ADDENDUM NO. 06
February 1, 2022

To Drawings and Specifications dated December 17, 2021

CLINE ELEMENTARY SCHOOL CAMPUS REPLACEMENT
FOR FRIENDSWOOD I.S.D.

Prepared by: PBK
11 Greenway Plaza, 22nd Floor
Houston, TX 77046-1104
PBK Project No: 20380

SITE DETAILS

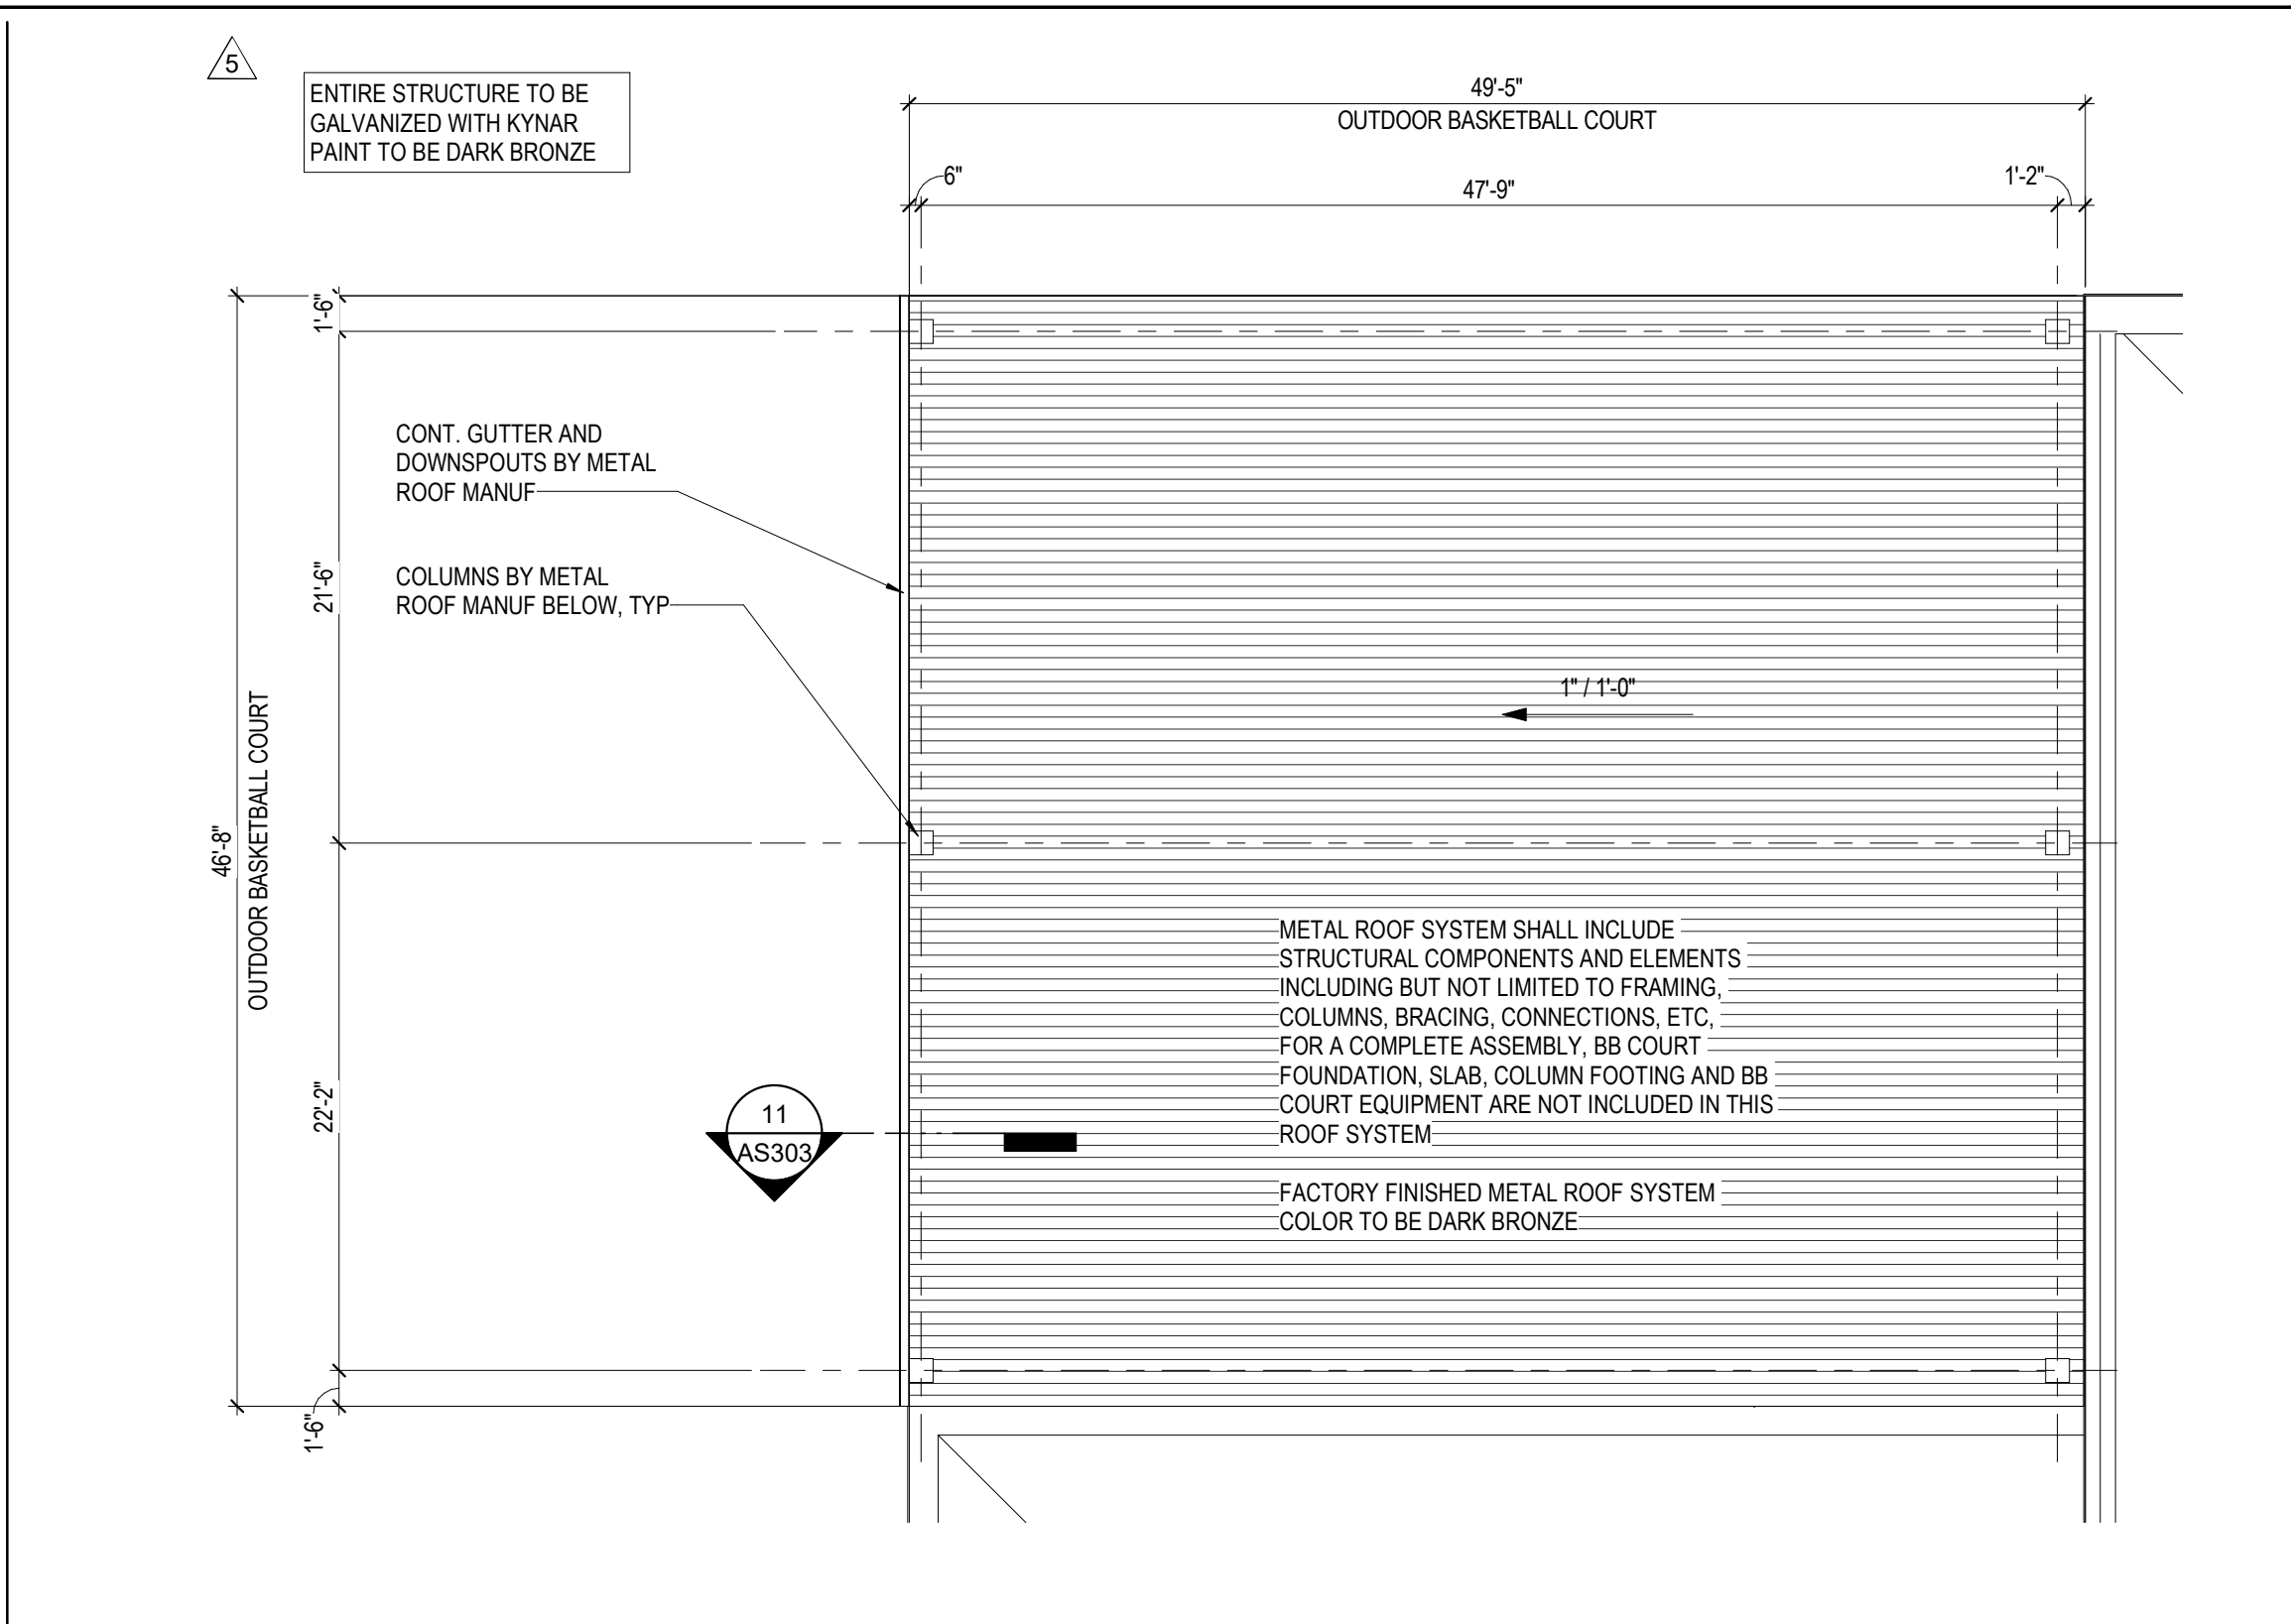
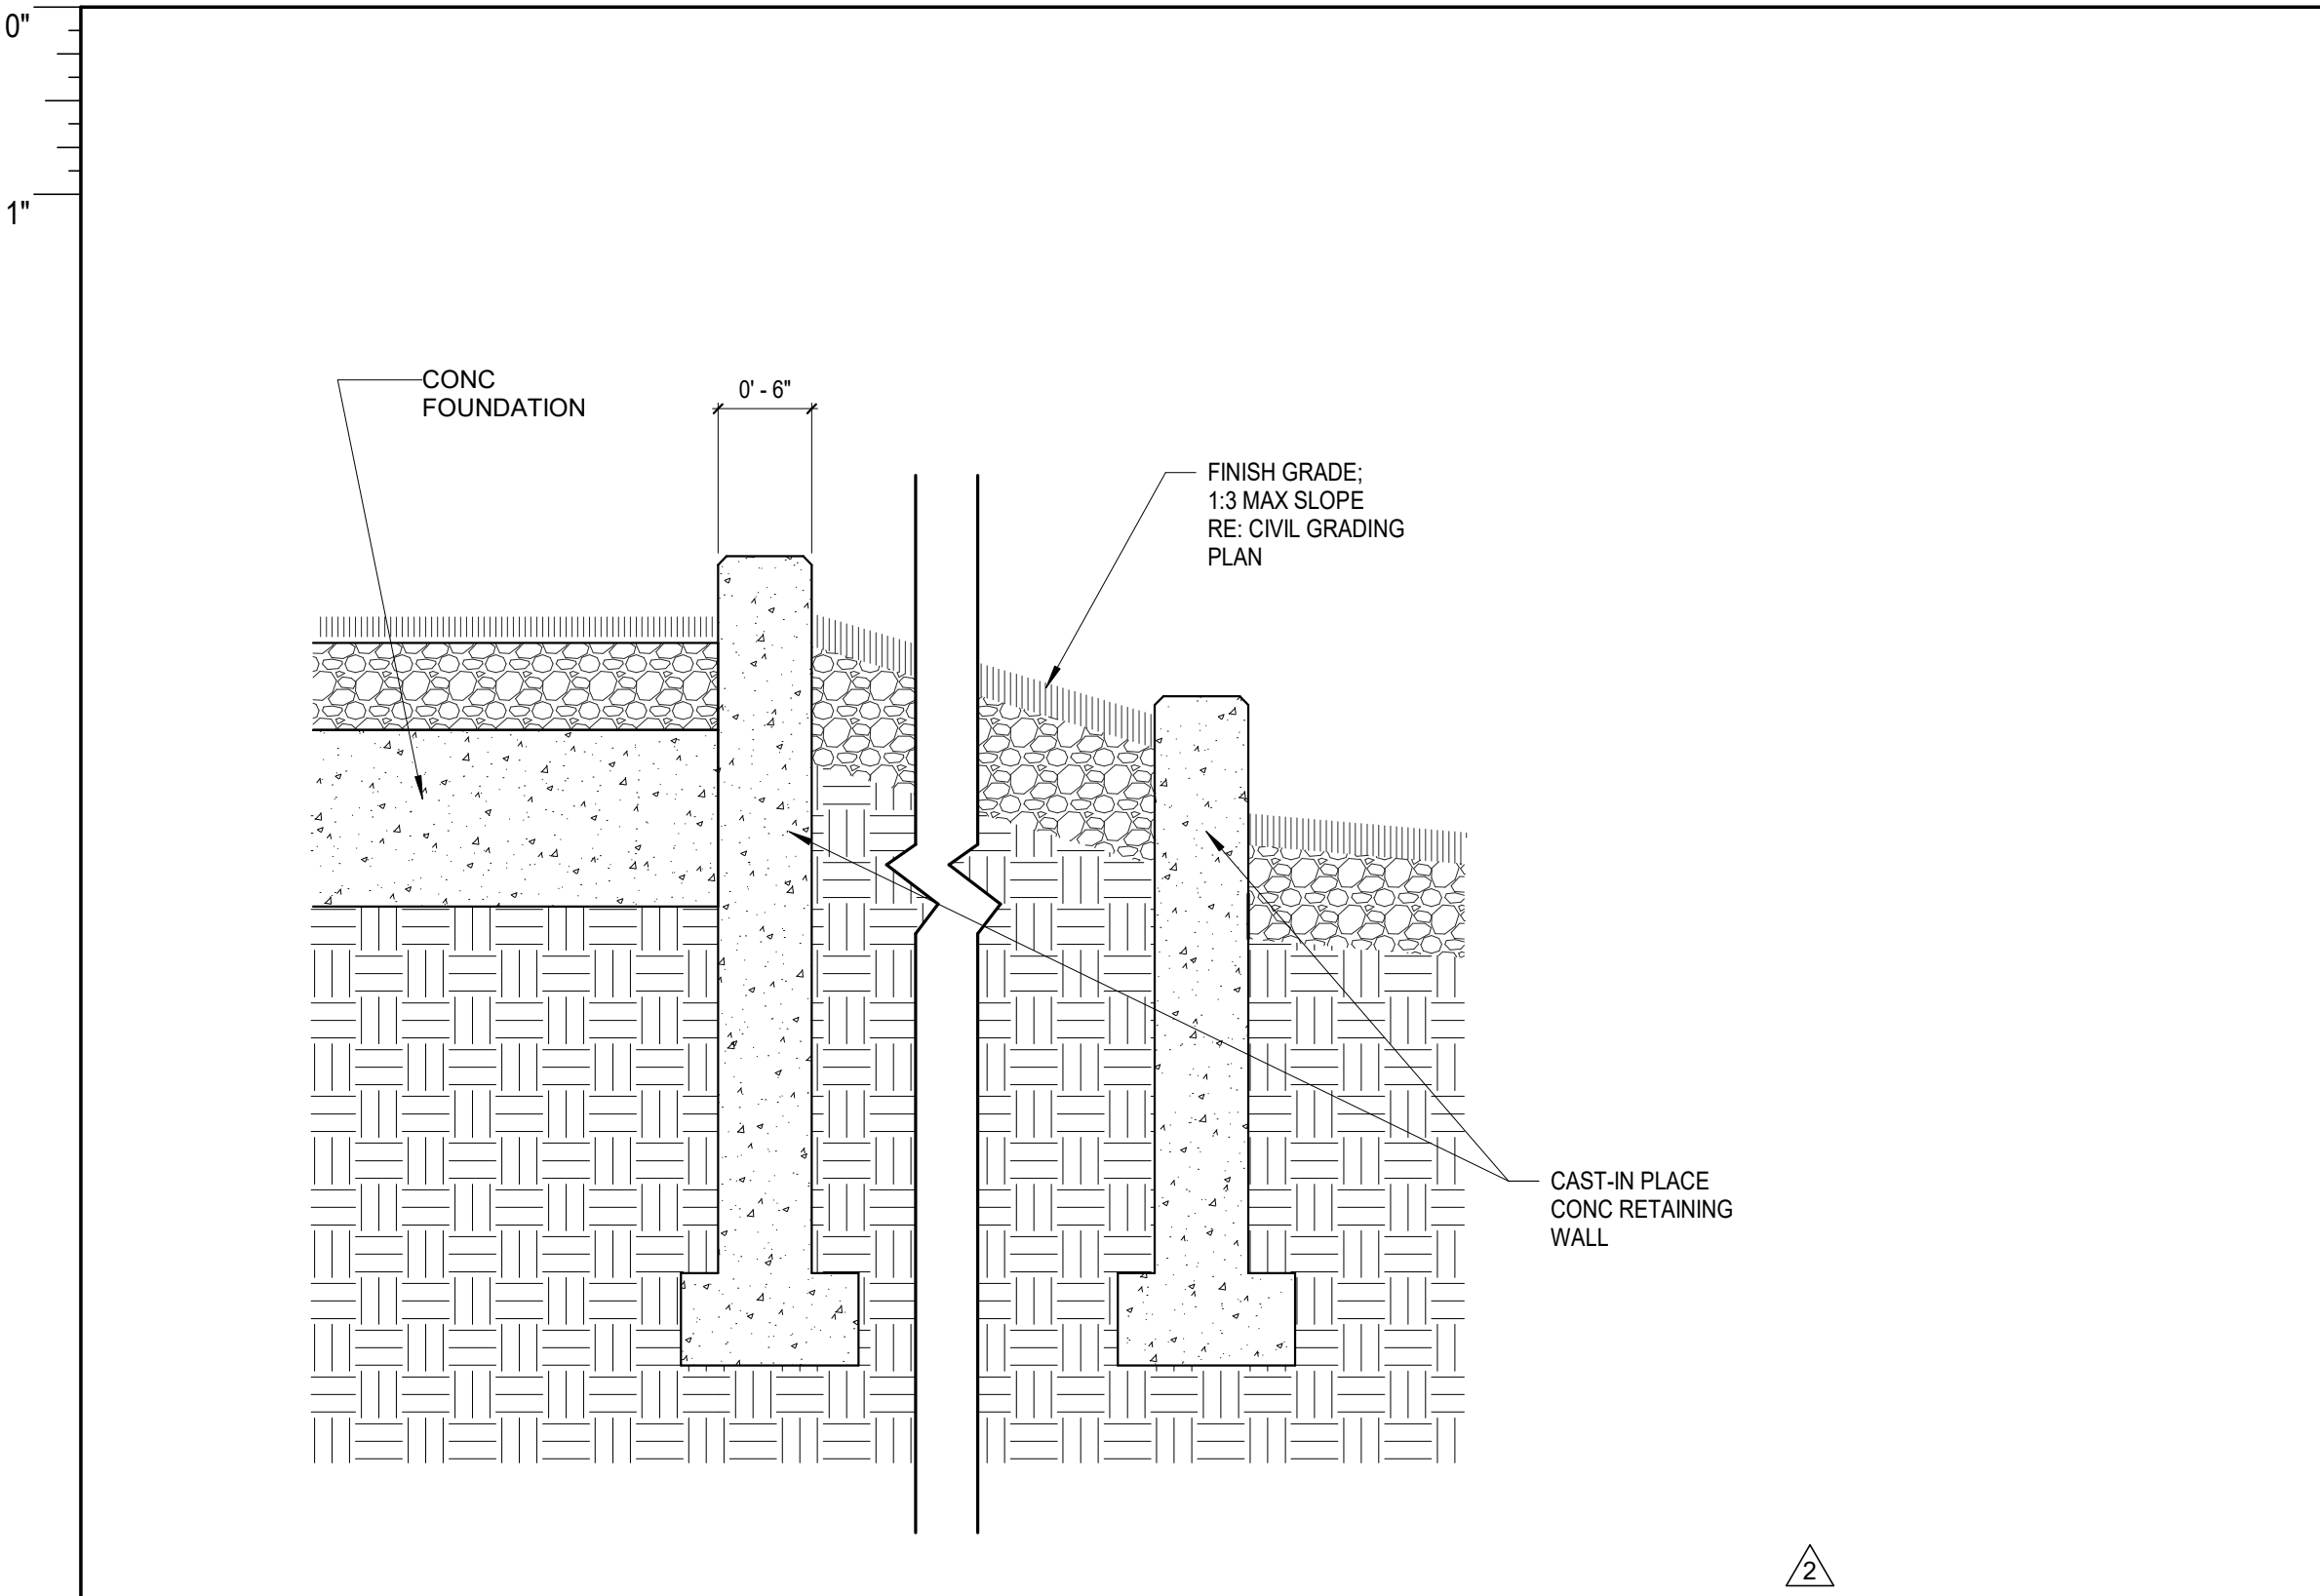
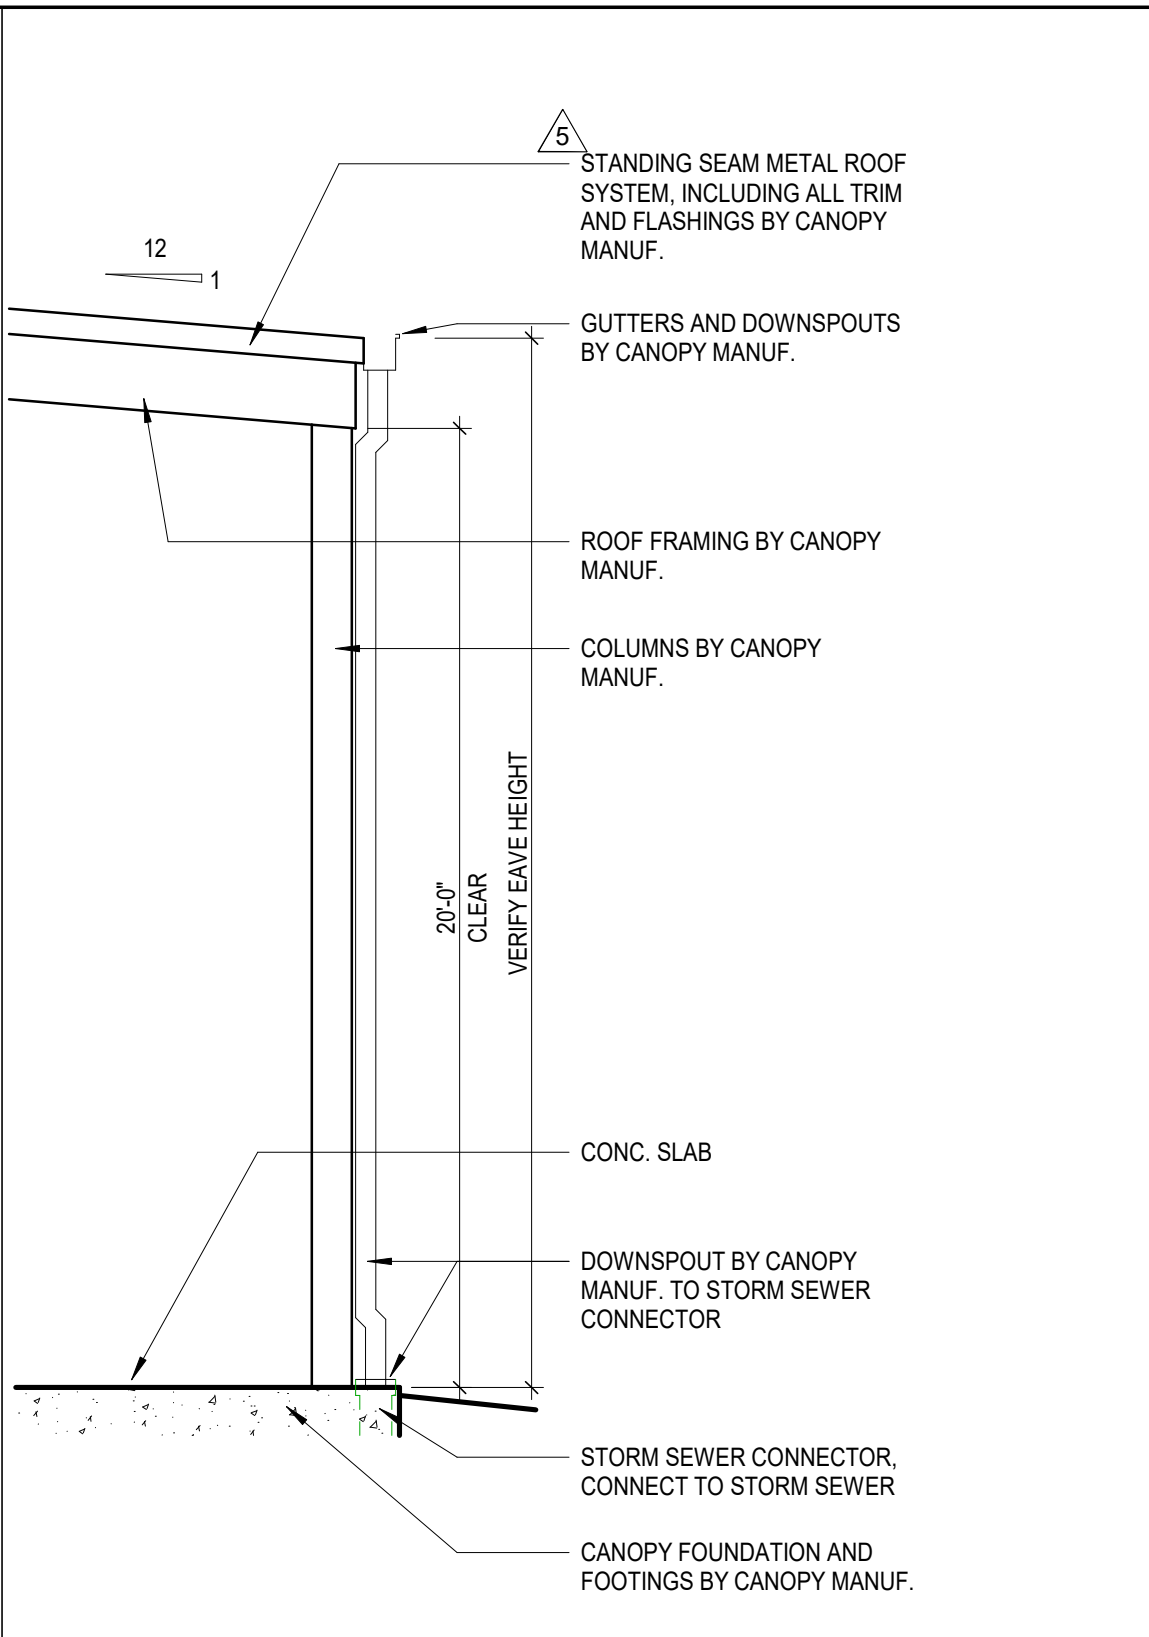
1. Revised marquee sign height to 5'.
